Proposal Request

Project: Black & Williams Community Center - Gymnasium Improvements

PR #4: Mechanical Pad and Fence Enclosure Dimensions

PR #7: ALUMINUM STOREFRONT BULKHEAD & JAMB EXTENTIONS

G MECHANICAL PAD PLAN
C2.1 SCALE: 1/4" = 1'-0"

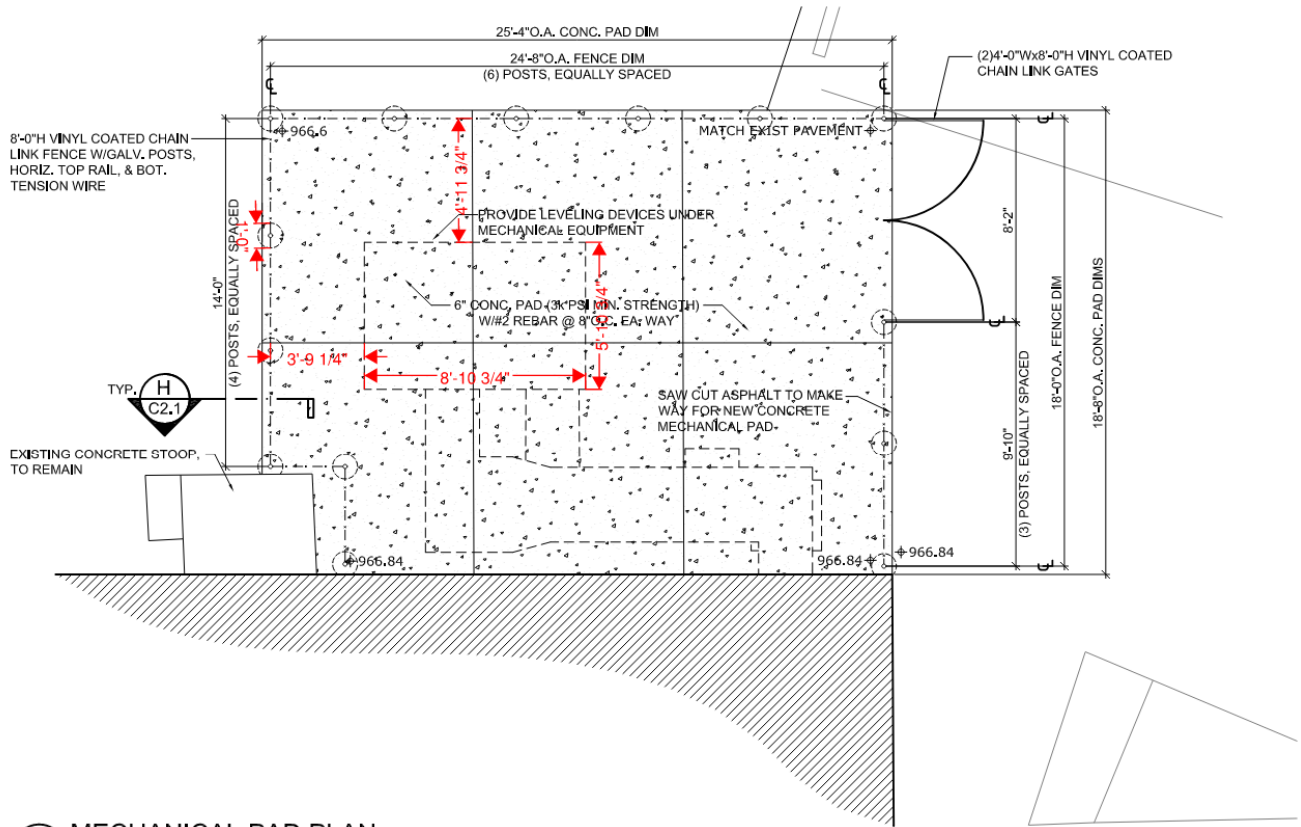
Per review Sheet C2.1 detail G/C2.1 references detail H2.1 and shows the slab has a turn down at -2' from BOS at the perimeter of the pad. Also, Sheet C2.1 show the fence details with the post cast deeper and wider than detail H2.1 turn down footings, top of post concrete is flush with the slab, and that the outside radius of the post concrete is outside of the edge of the slab. Lastly M6.0 shows a different mechanical pad altogether. Per previous correspondence the current placement of the GMU will not have proper clearances as well per detail G-C2.1 per the approved GMU unit submittal. Please confirm how design wants to proceed.

PAD SIZE AS SHOWN ON THE DRAWINGS SHOULD BE SUFFICIENT FOR THE NEW UNIT/CLEARANCES IF THE UNIT PLACEMENT IS ADJSUTED. THIS NEEDS TO BE COORDINATED WITH THE INLINE EXHAUST IN ORDER TO CONFIRM. WE DO NOT HAVE INFORMATION ON THE EXHAUST TO EVALUATE.

GMU - ELEVATION

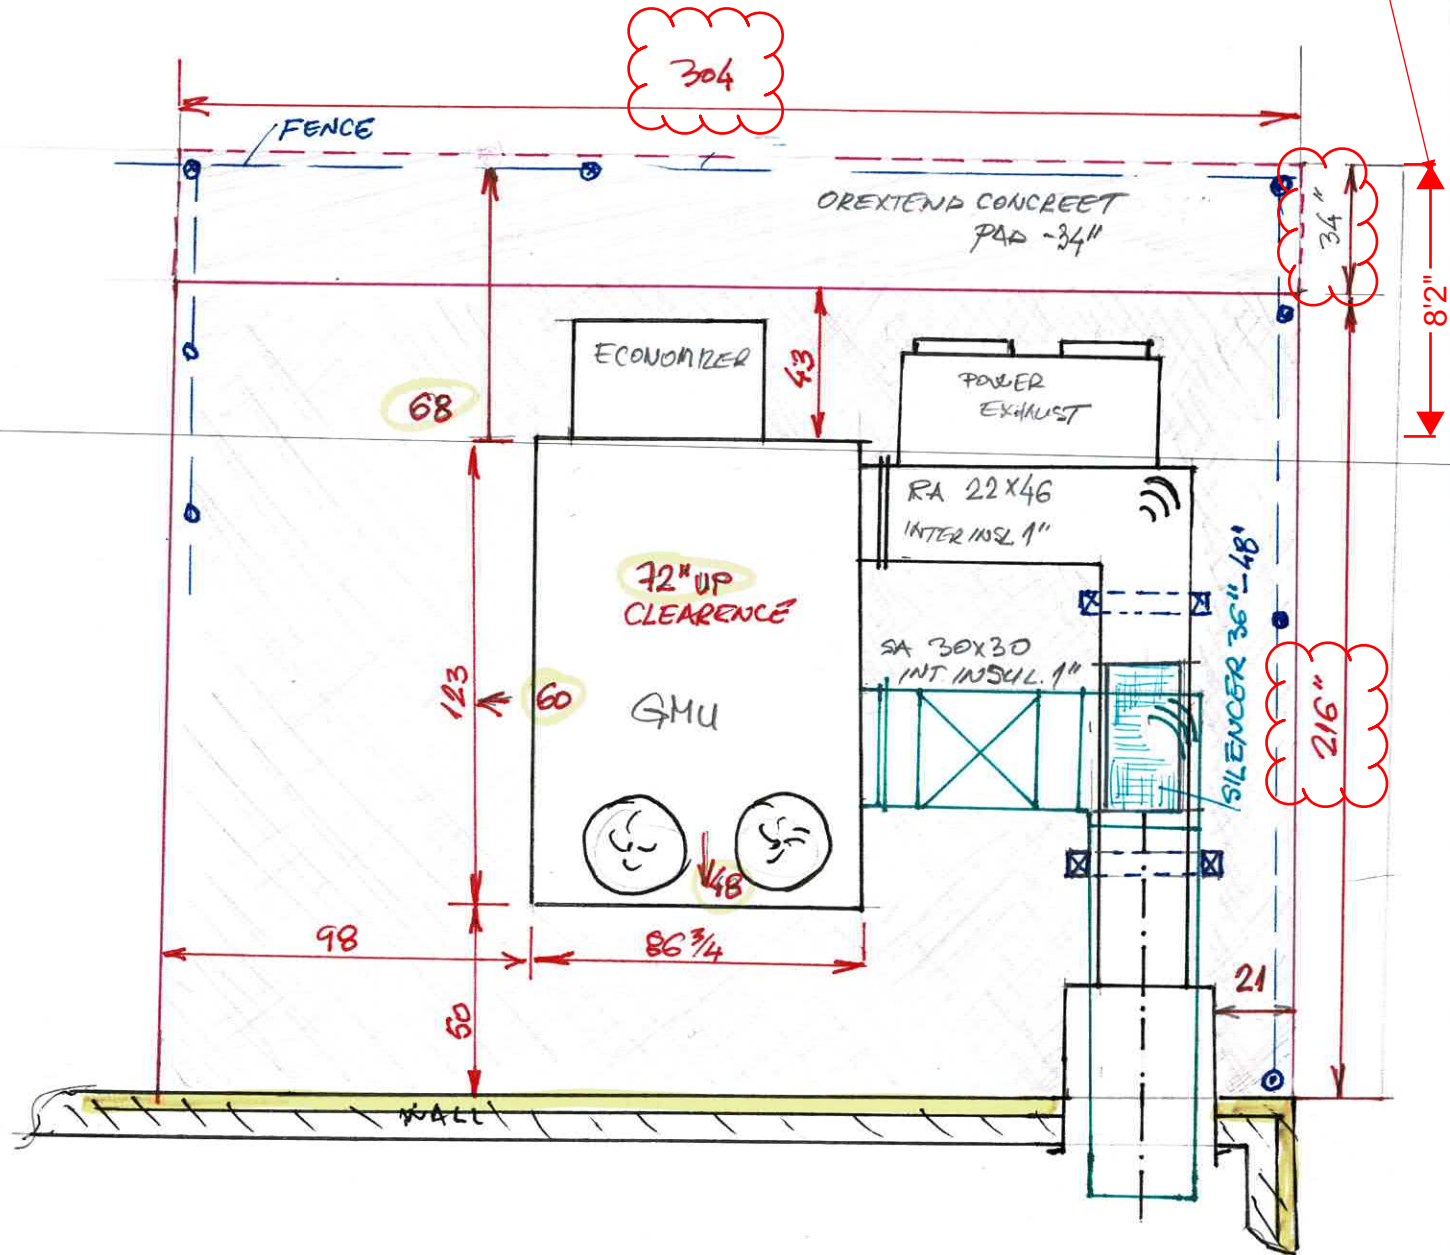
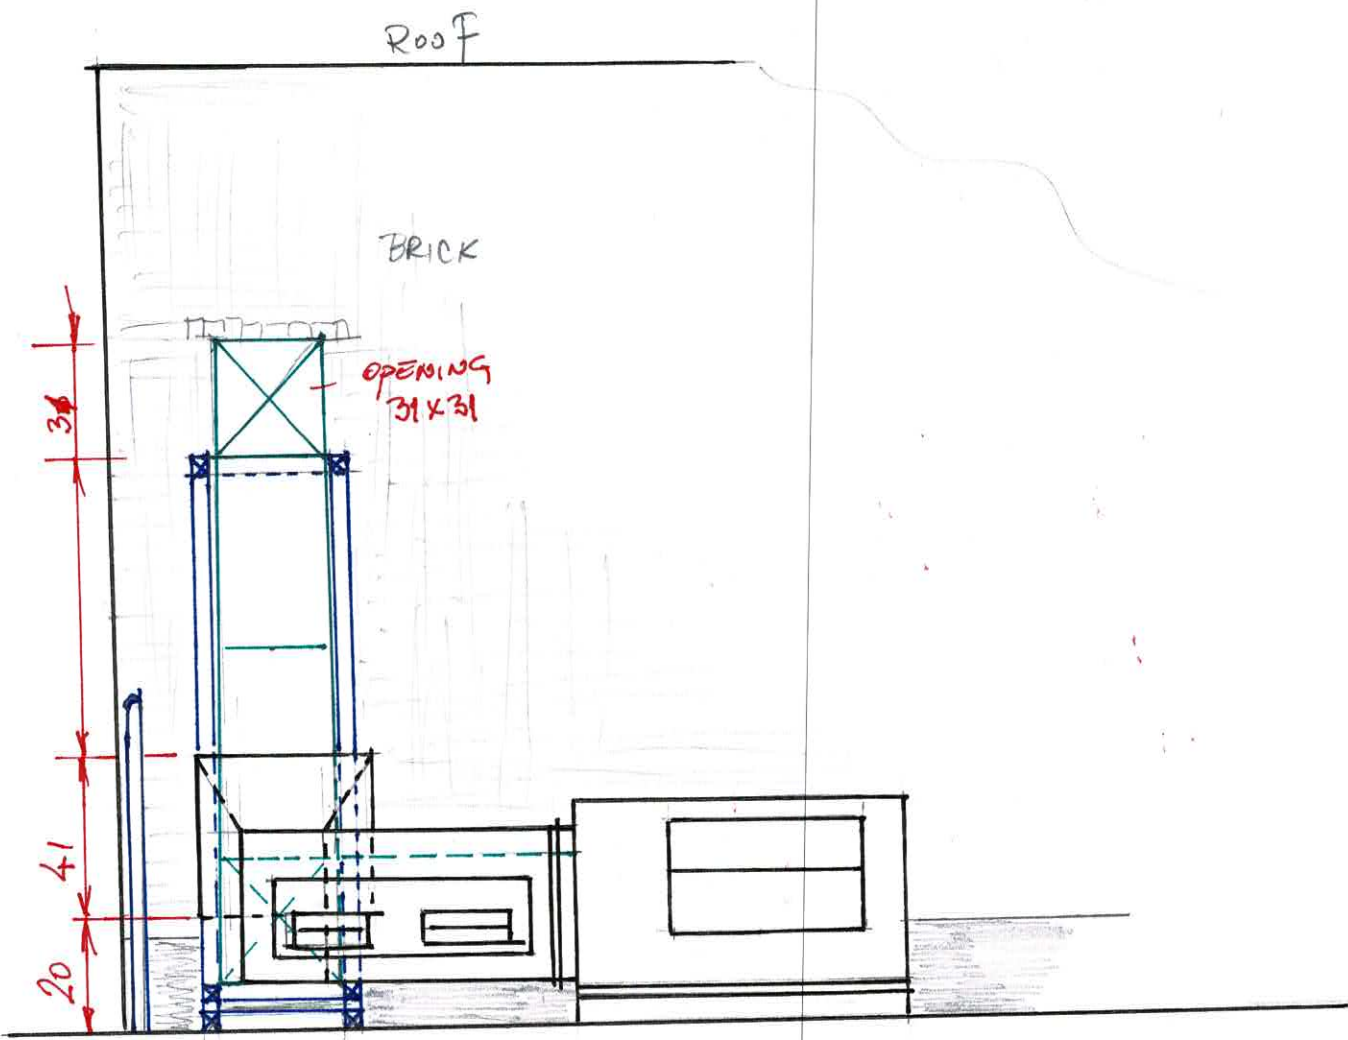
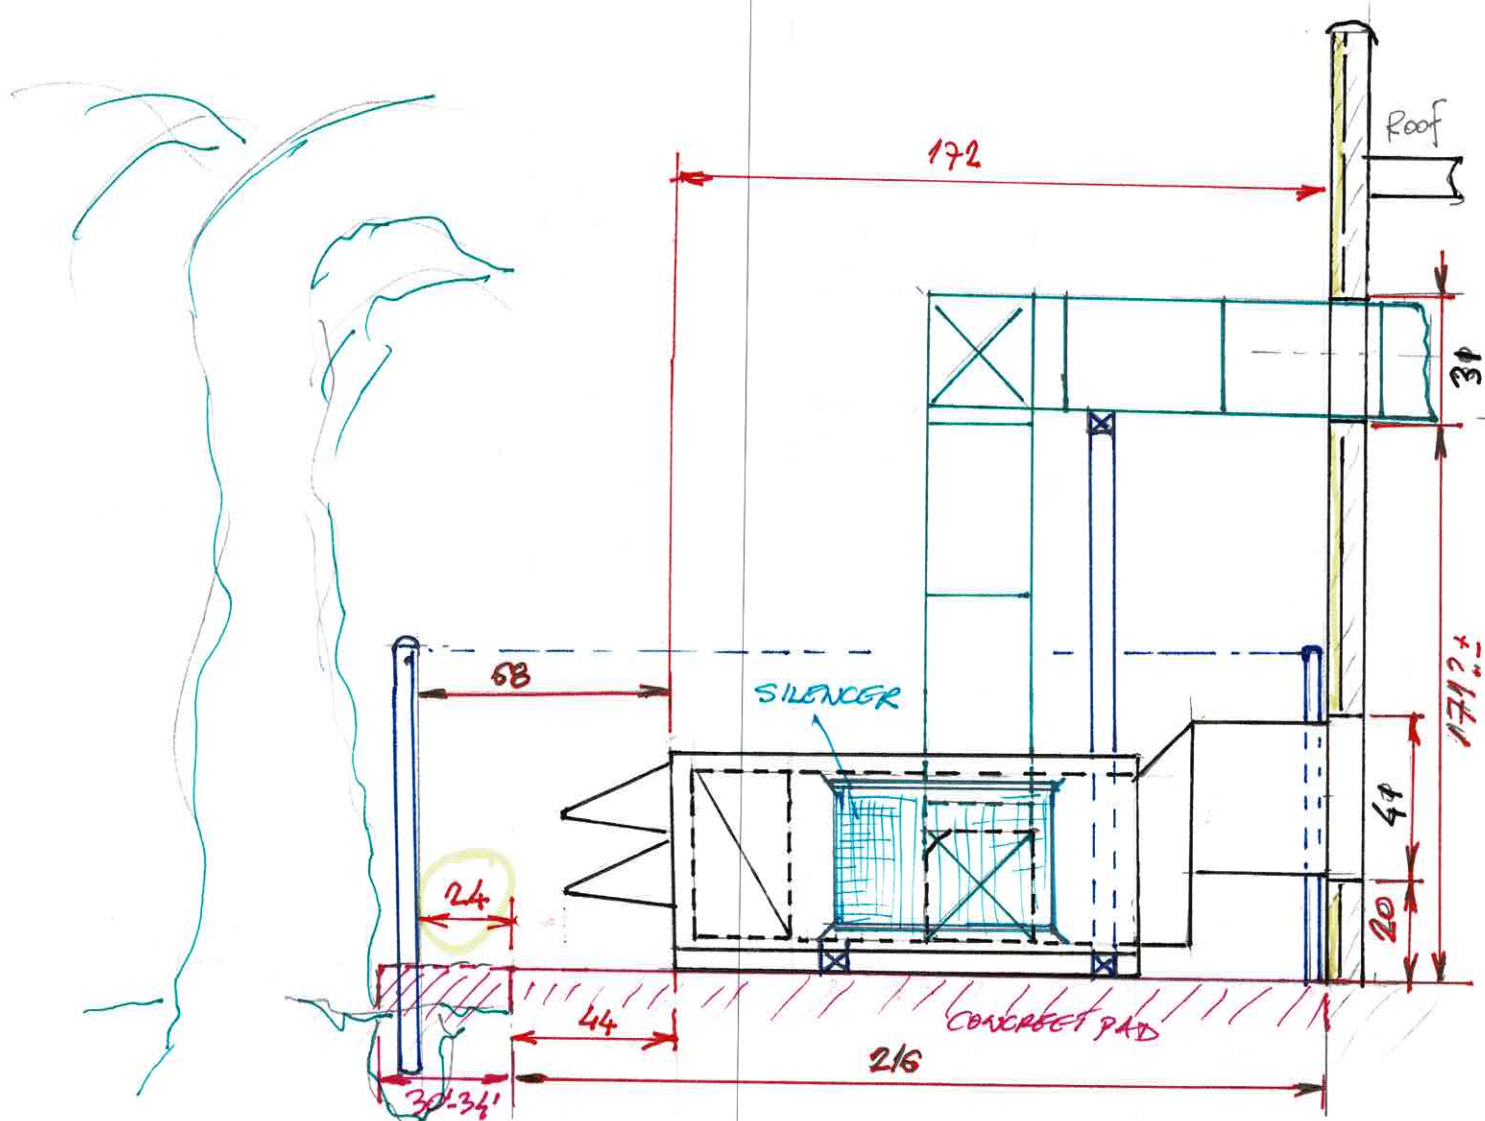
1. Gate opening and location as shown in drawings is fine per Mr. HVAC.
2. Clouded Red dimensions as shown must be clear space to the fences.
3. Where fence is moving out 34" it would be best to have concrete paving.

Fence Need to be moved
OR EXTEND CONCRETE PAD 30-34"

G MECHANICAL PAD PLAN

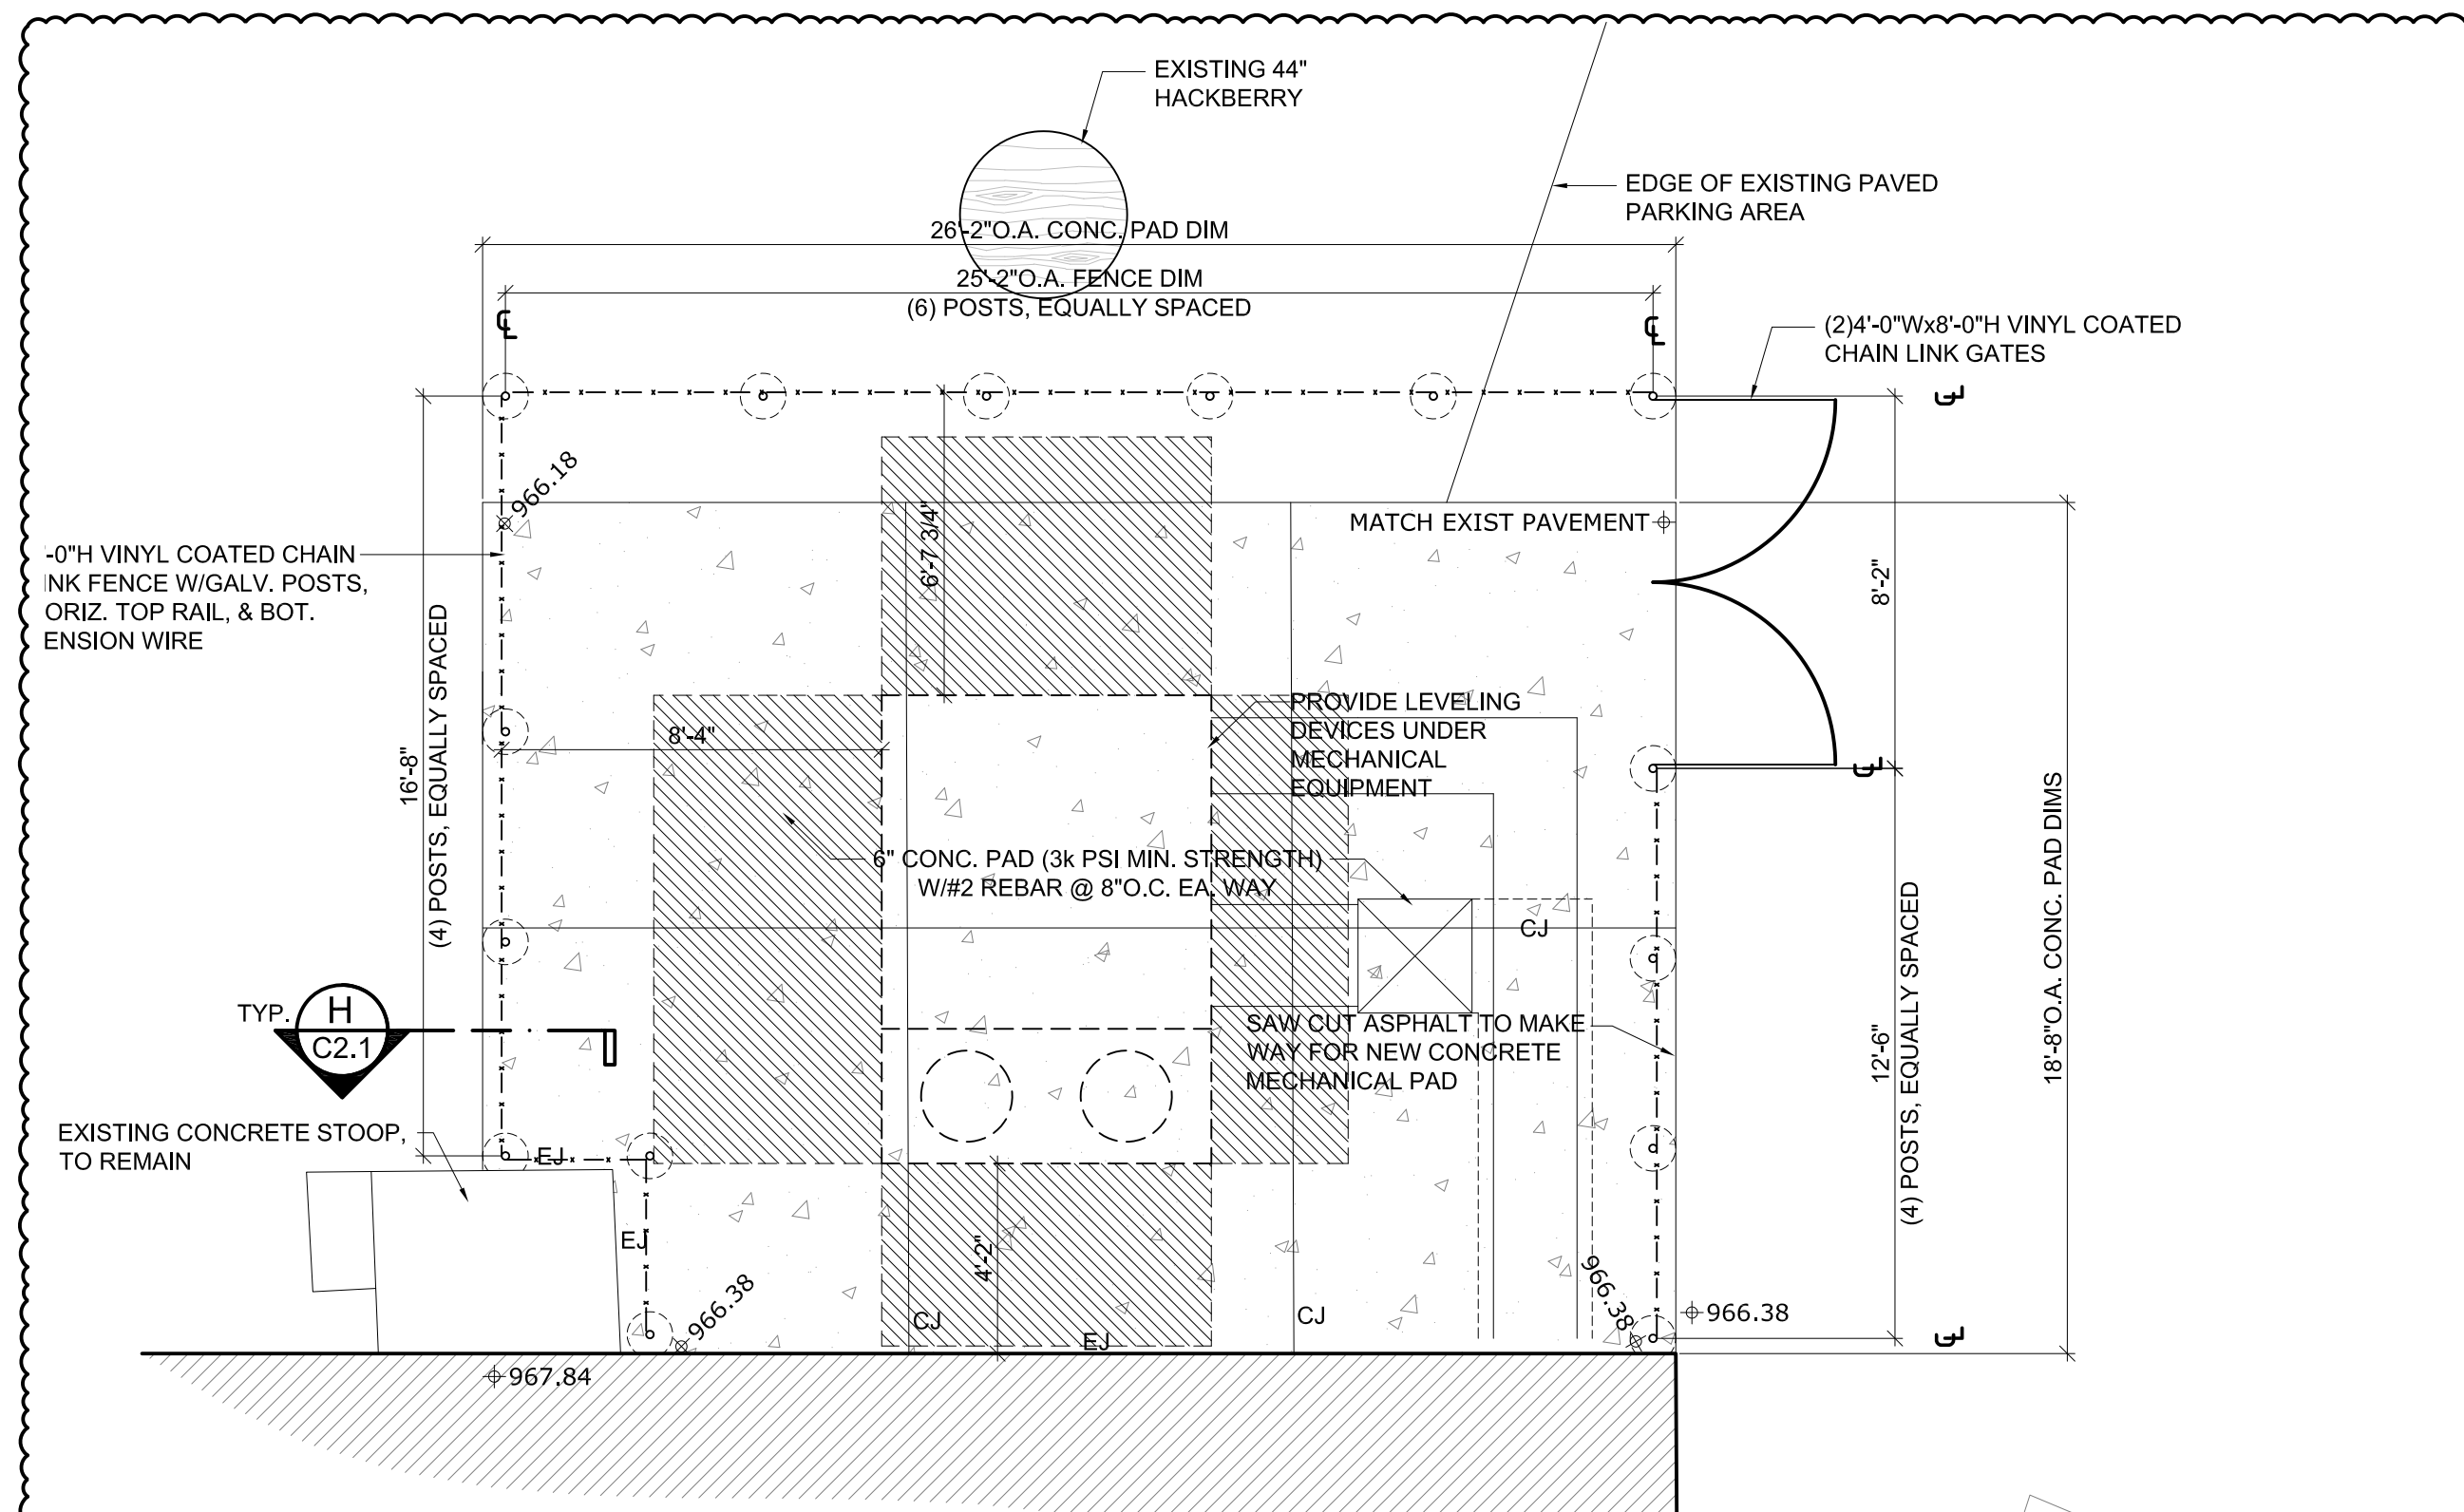
Due to the requirements of the GMU being provided in lieu of the original specified unit being unavailable, the overall dimensions and layout of the equipment pad and fencing will need to be adjusted (**see RFI#16**) as below:

- See updated detail G/C2.1
- Add approximately 5'-4" linear feet of fencing.
- Add approximately 10 square feet to the equipment pad.
- Field verify all quantities.
